VIRGINIA ELECTRIC AND POWER COMPANY
RICHMOND, VIRGINIA 23261

September 13, 2005

Serial No. 05-601
NL&OS/GDM R0
Docket Nos. 50-280
50-281
License Nos. DPR-32
DPR-37

VIRGINIA ELECTRIC AND POWER COMPANY
SURRY POWER STATION UNITS 1 AND 2
PROPOSED TECHNICAL SPECIFICATIONS CHANGE
REDEFINITION OF EXCLUSION AREA BOUNDARY

Figure 1: Surry Site Map with Wind Sectors

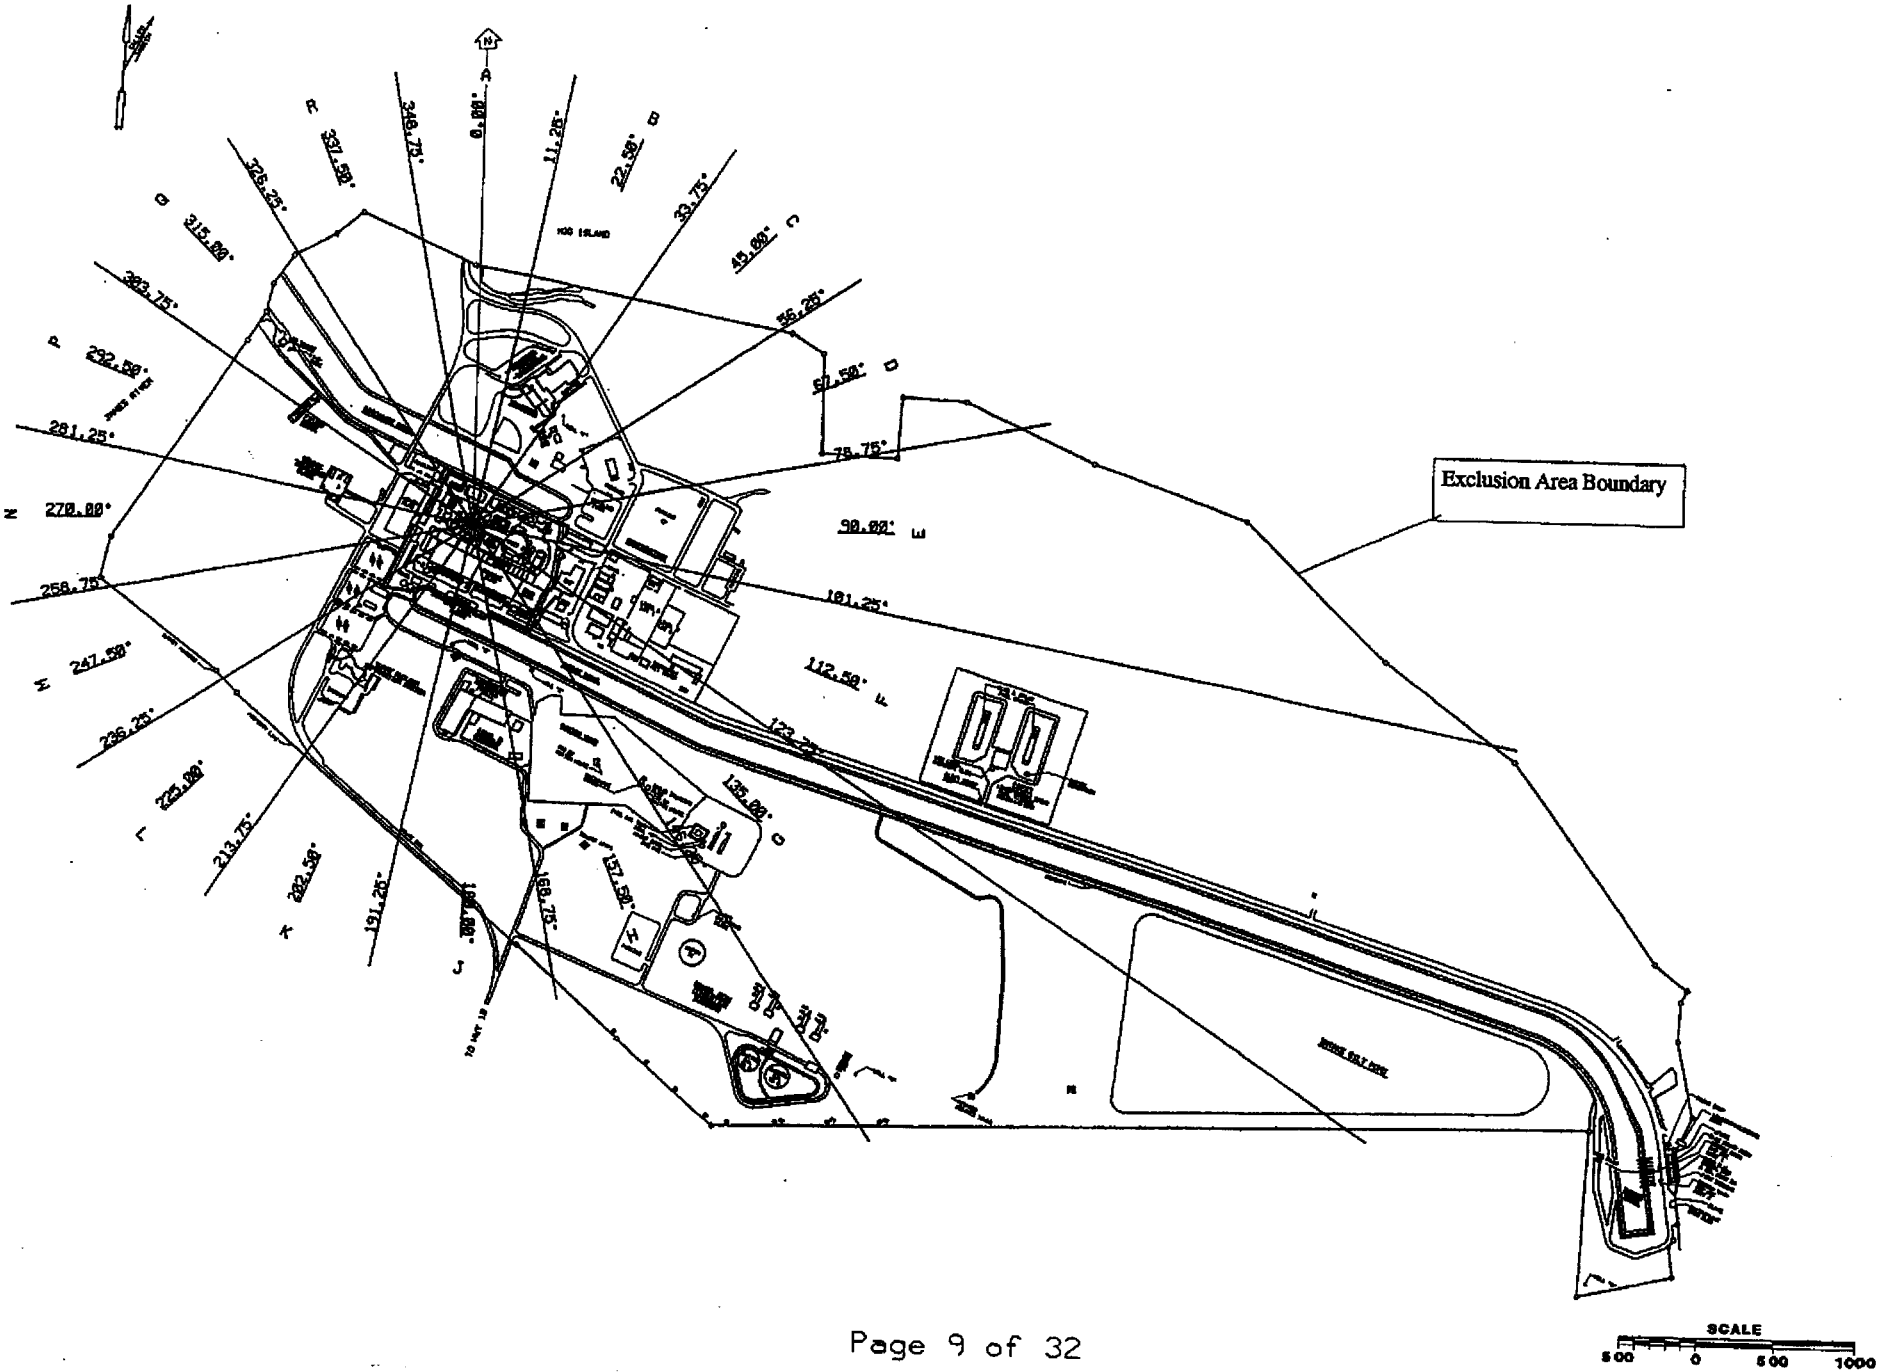
Figure 1 is the site map that was used to determine the minimum distances from the potential source release points to the closest point on the site boundary within each wind sector. Figure 1 also shows the wind sector definition lines that were used to determine the sector dependent distances to the site boundary from the centerline of the Unit 1 Containment. Similarly, the wind sector definition lines were centered over the approximate location of each of the remaining source points in Table 1 in order to determine the minimum sector dependent distances to the site boundary from each source point.

Figure 2: Simplified Surry Site Plan Including Potential Source and Onsite Receptor Locations
(updated to include the Steam Generator PORVs and safety valves)

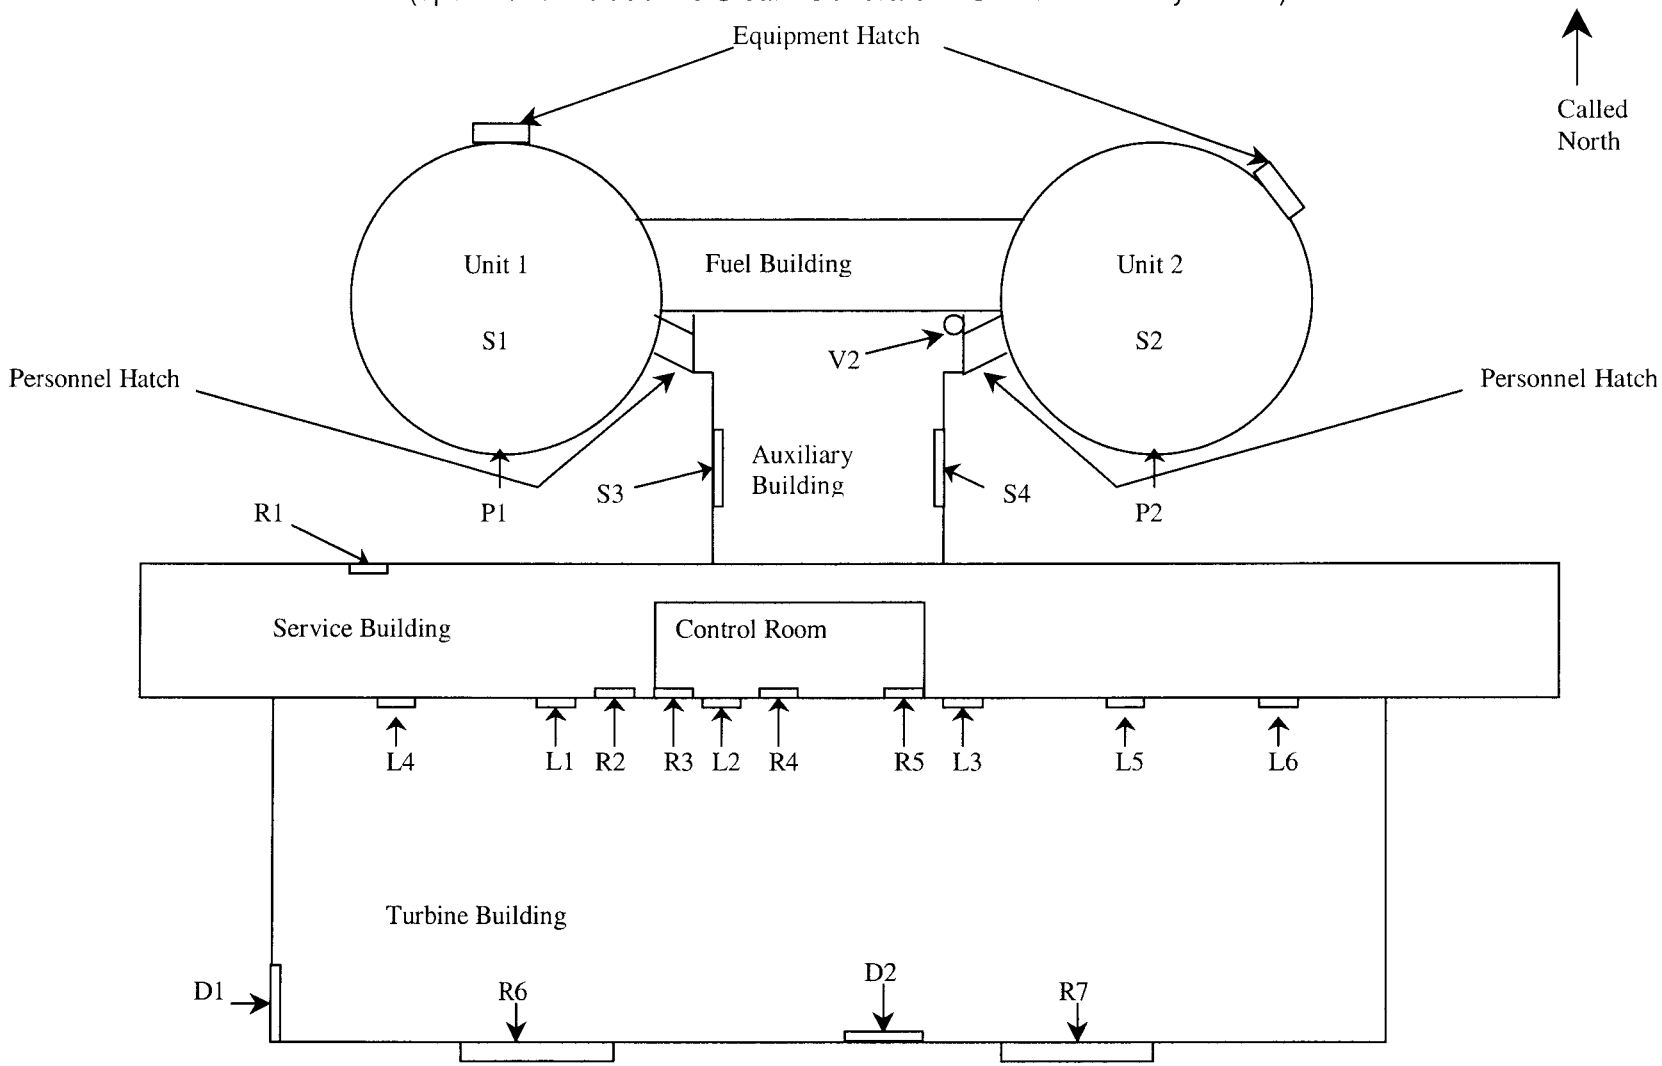
Figure 2 is a simplified site plan that was originally included in Reference 8, which was updated to include the steam generator PORVs and safety valves. As shown on Figure 2, the steam generator PORVs and safety valves are located against the southern side of the Unit 1 and Unit 2 containments. Based on inspection of the site geometry shown in Figures 1 and 2 and the results of Table 5 (PAVAN output), atmospheric dispersion from the PORVs and safety valves to the site boundary would be bounded by the Unit 1 Containment source location. Hence, the value 1.79E-03 sec/m^3 would be appropriate to use as an EAB X/Q for all accidents that have source locations that are bounded by the dispersion from the Unit 1 Containment.
